ROCHESTER GAS AND ELECTRIC CORPORATION • 89 EAST AVENUE, ROCHESTER, N.Y. 14649

June 22, 1979

Subject: IE Bulletins 79-06A and 79-06A Revision I entitled "Review of
Operational Errors and System Misalignments Identified
During the Three Mile Island Incident" - additional informa-
tion requested during staff review of responses
R. E. Ginna Nuclear Power Plant, Unit No. 1
Docket No. 50-244

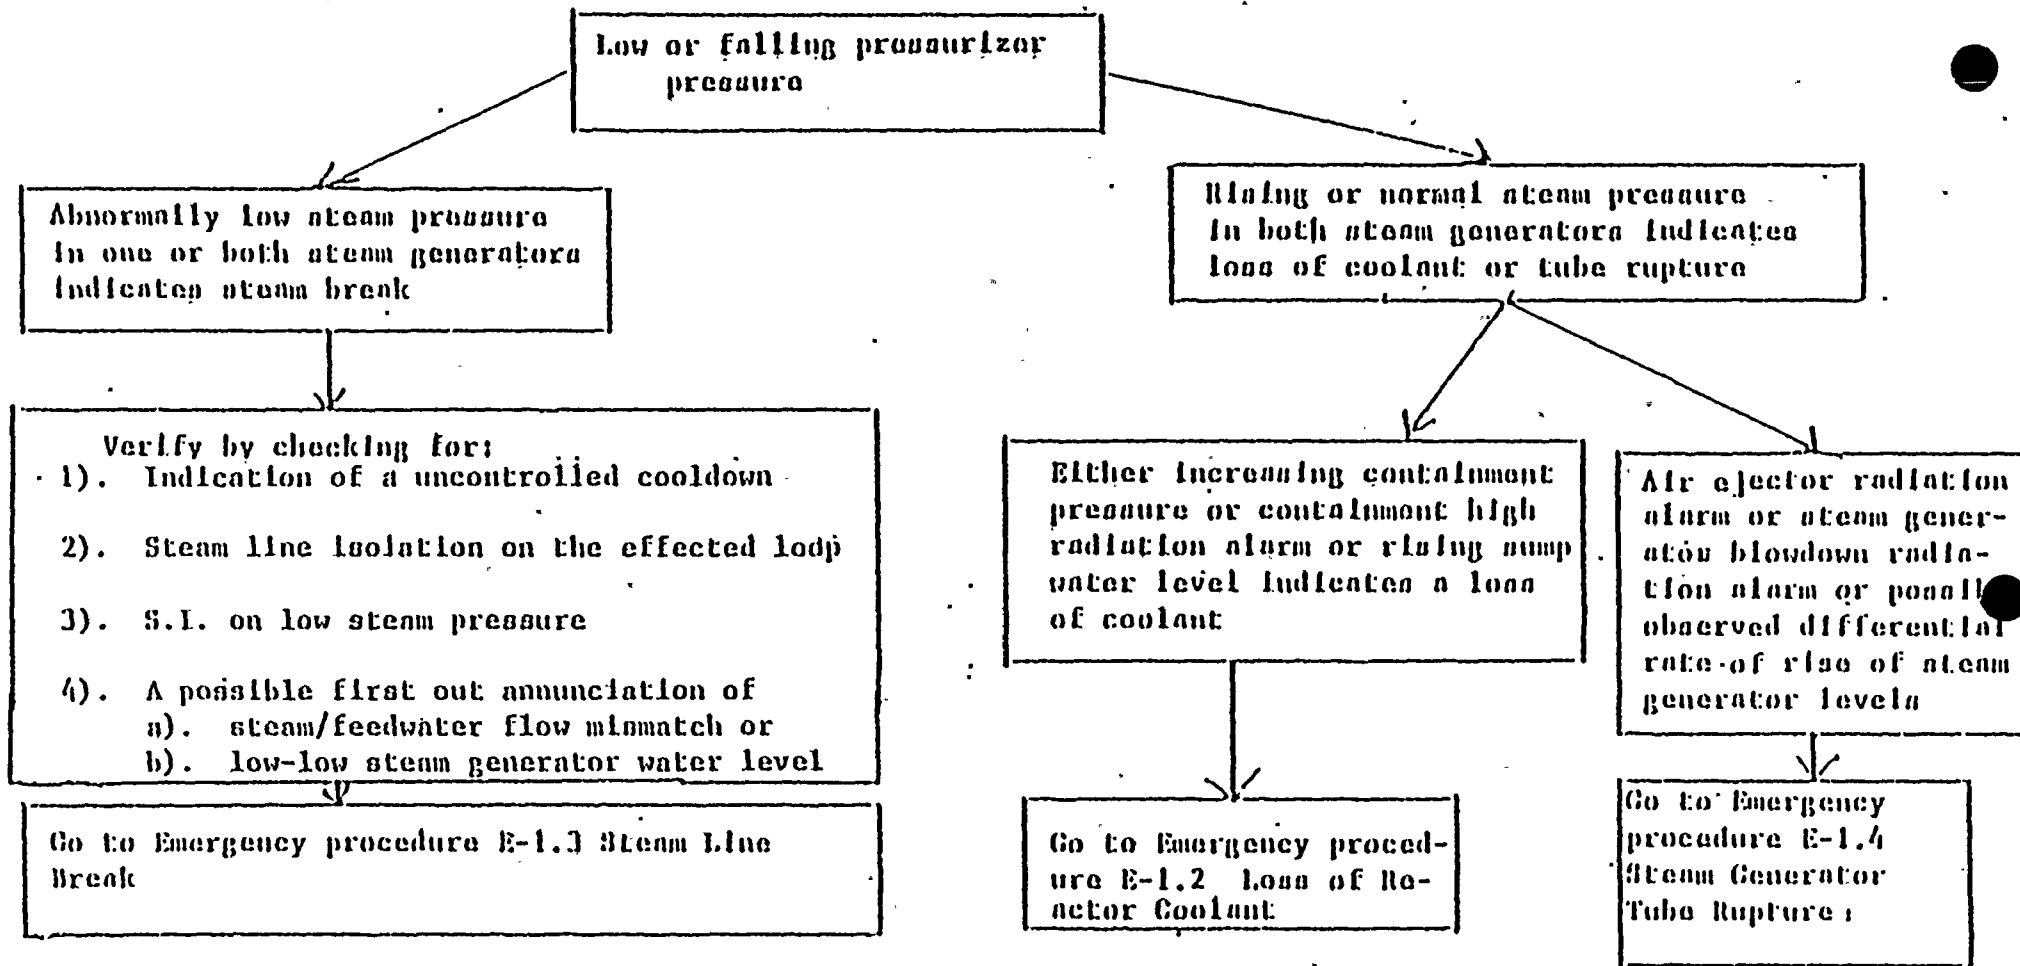
PLEASE VERIFY THAT THE IDENTIFIED PARAMETERS HAVE BEEN INCLUDED IN APPROPRIATE OPERATING PROCEDURES.

Pressurizer level has been eliminated in the diagnostic scheme for the identification of accident category. Pressurizer level has also been removed as a symptom from all RCS accident procedures except CVCS break. The operator is directed to other indications for accident identification. The diagnostic tree is attached.
